**SECTION 16 APPLICATION
TOWN PLANNING ORDINANCE (CHAPTER 131)**

**PROPOSED SOCIAL WELFARE FACILITY (RESIDENTIAL CARE HOME FOR PERSONS WITH
DISABILITIES) IN "VILLAGE TYPE DEVELOPMENT" ZONE ON APPROVED NAM SANG WAI
OUTLINE ZONING PLAN NO. S/YL-NSW/10 AT LOTS 3669 S.A RP (PART), 3669 S.B RP (PART),
3670 RP (PART) AND ADJOINING GOVERNMENT LAND IN D.D.104, NAM SANG WAI, YUEN LONG**

Town Planning Application No. A/YL-NSW/348 - Submission of Further Information (6)

Response-to-Comment Table

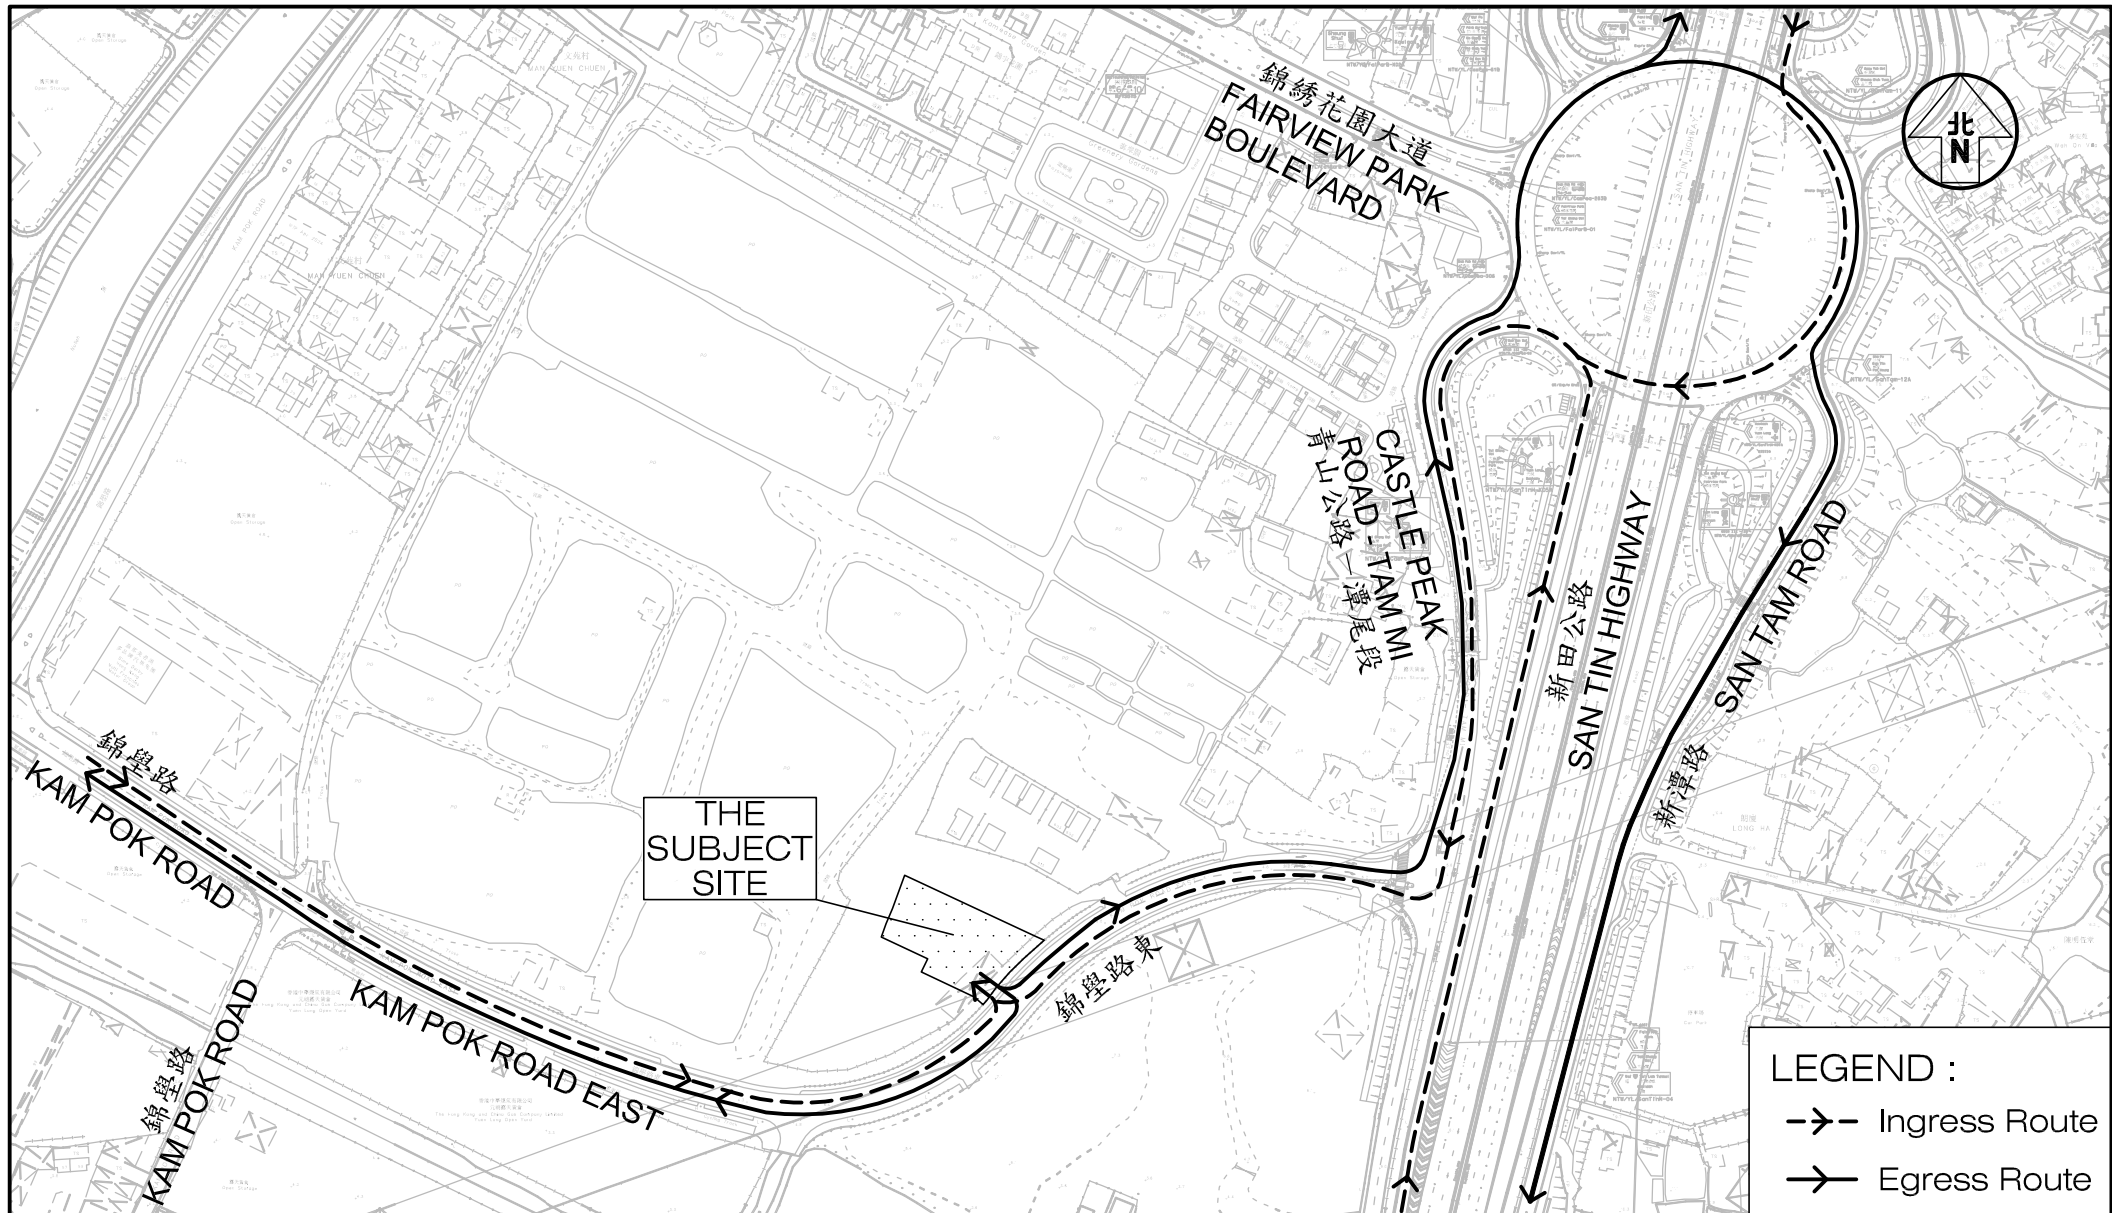
2.	Given the congested area at the site entrance, the management staff should be on-site at all time to manage the traffic.	Noted.
3.	Re. RtC Item 6: It appears that your checking of visibility splay has not taken into account of the existing planter. Please revisit the checking and demonstrate sufficient sightline could be maintained at all time since the commissioning of RCHE.	In order to ensure the adequate sightline for vehicles and pedestrian, the amendment of existing planter is needed to ensure no obstructions taller than 1.05m will be erected within the visibility splay at the run-in/out.

- 3.4 The carpark layout plans for G/F and B/F are shown in Figures 3.1 – 3.2.
- 3.5 The measured length of visibility splay for the motorists leaving the Proposed RCHD is 60m to the left and 60m to the right, which is illustrated in Figure 3.3.

FIGURE 3

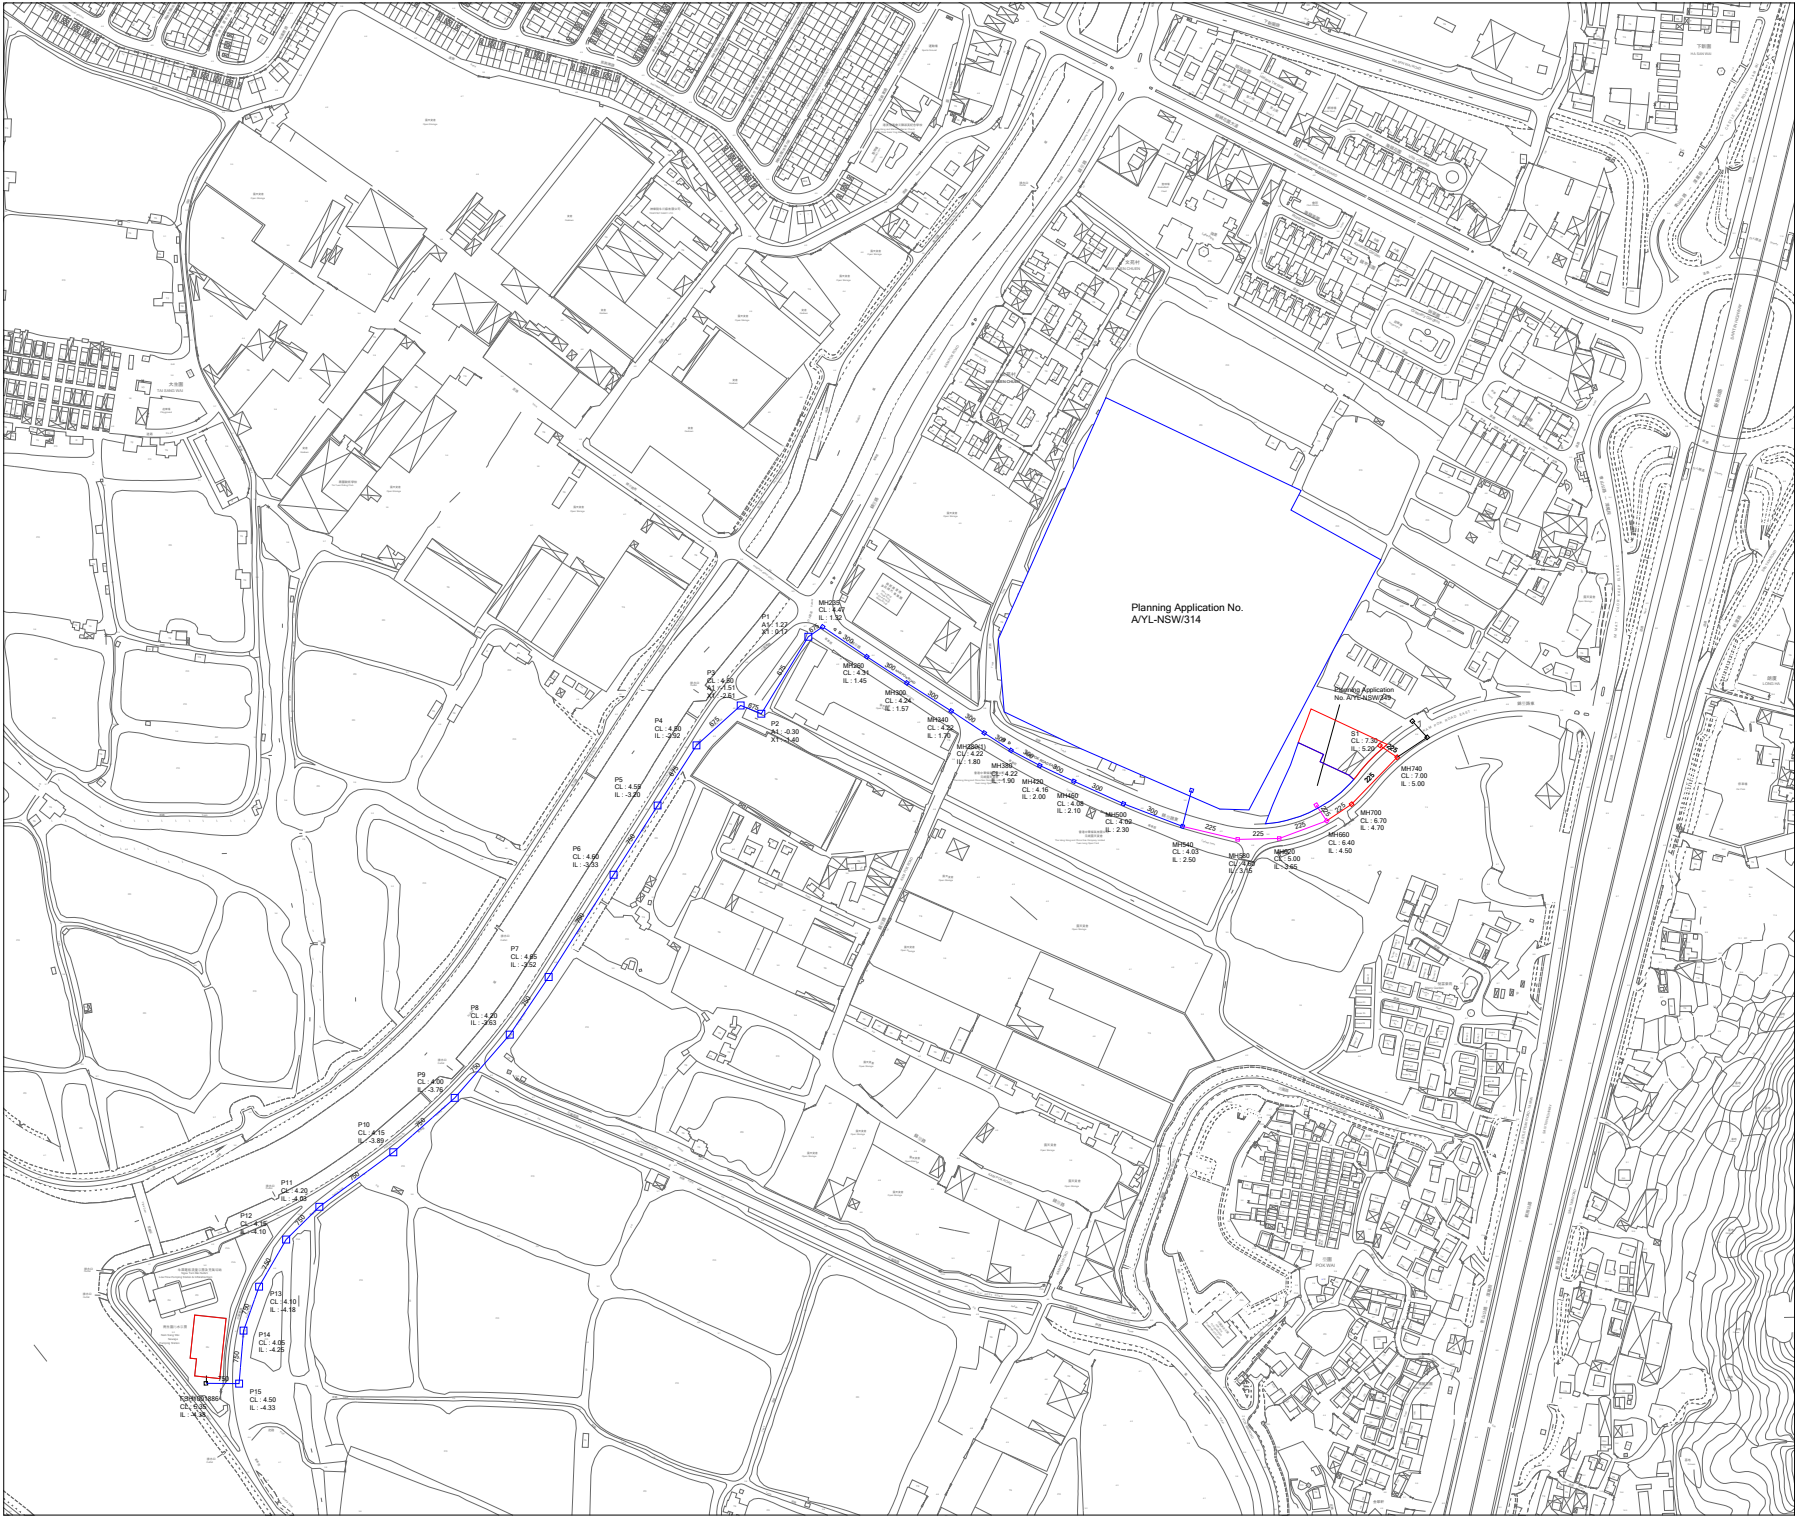
1.	Sewerage RtC item 2(a) & Section 2.3.1 – Please delete the second last sentence if the information has been included under Table 2.2.	See revised Sewerage Impact Assessment (Appendix 3). The sentence has been deleted.

2.	RtC item 2(b) & Section 2.3.1 – Should “MH660 to MH 580” read “MH660 to MH 540”?	The Section has been revised to “MH660 to MH 540”.
3.	RtC item 3, Section 2.3.2 & Section 2.4.2 & Appendix B – Please confirm and state if the planned sewers mentioned under Section 2.4.2 means proposed sewers P1 to P15 and upgraded sewer MH540 to MH235 under planning application No. A/YL-NSW/314 and proposed sewers MH660 to MH580 under planning application No. A/YL-NSW/349, and if other sewers as proposed by other planning applications mentioned under Section 2.3.2 are not proposed to be utilised by the proposed development under this SIA. If this is the case, a hydraulic assessment adopting proposed sewers P1 to P15 and upgraded sewer MH540 to MH235 under planning application No. A/YL-NSW/314 and proposed sewers MH660 to MH580 under planning application No. A/YL-NSW/349 would serve the purpose and the last two sentences of Section 2.3.2 should be deleted. If not, please consider different sewage disposal scenarios in the SIA including hydraulic assessment.	It is confirmed that planned sewers mentioned under Section 2.4.2 means proposed sewers P1 to P15 and upgraded sewer MH540 to MH235 under planning application No. A/YL-NSW/314 and proposed sewers MH660 to MH580 under planning application No. A/YL-NSW/349. The last two sentences of Section 2.3.2 had been deleted.

4.	Section 2.4.2 – Please revise the second sentence as “In case these planned sewers i.e. proposed sewers between MH235 to FSH1001886 and upgraded sewers between MH540 to MH235 under planning application No. A/YL-NSW/314 and proposed sewers between MH660 to MH540 under planning application No. A/YL-NSW/349 are not available...”.	Revised.
